The Cadillac Serviceman

SEPTEMBER, 1957

TWO TYPES OF PISTONS USED IN 1957 PRODUCTION

FIG. 4.

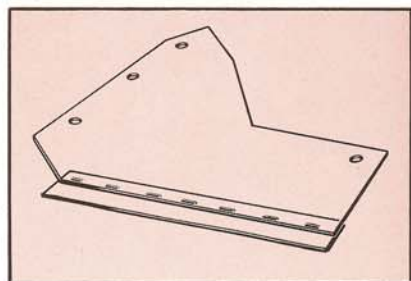
THERE have been occasional reports from the field of the radiator air deflector to front bumper seal hanging down below the bumper on some 1957 cars.

Servicemen can correct this condition by stapling a $1\frac{1}{2}$ " x $12\frac{9}{16}$ " piece of acromat to the deflector seal as shown in Fig. 4. Thus, by lengthening the seal, it can be tucked up further into the bumper, preventing any possibility of its slipping down and becoming exposed.
